NHTSA Recall:	26V-276	Product:	Lineage Roof-Mounted Solar Panels
TC Recall:	2026-210	Repair Time:	0.5h / panel

This document outlines the procedure to install a mechanical rail retention system over each roof-mounted solar panel on affected Lineage motorhomes. The procedure supplements the original adhesive installation with EternaBond sealing tape, foam-mounted aluminum rails, and stainless fasteners to provide positive mechanical retention of the panel to the roof.

Fig. 3 — Completed EternaBond application prior to rail installation.

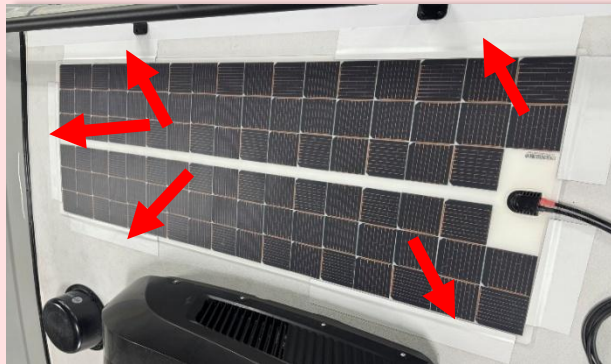
Step 2 — Apply five 18" pieces of EternaBond tape to seal the remaining panel perimeter: two pieces along each side of the panel, and one piece along the opposite end from the power cord side.

Note: Overlap adjacent pieces by a minimum of 1" to maintain a continuous seal.

Step 3 — Using a J-roller or hand roller, firmly roll each piece of EternaBond to activate the adhesive and eliminate air pockets. Roll from the center of each piece outward.
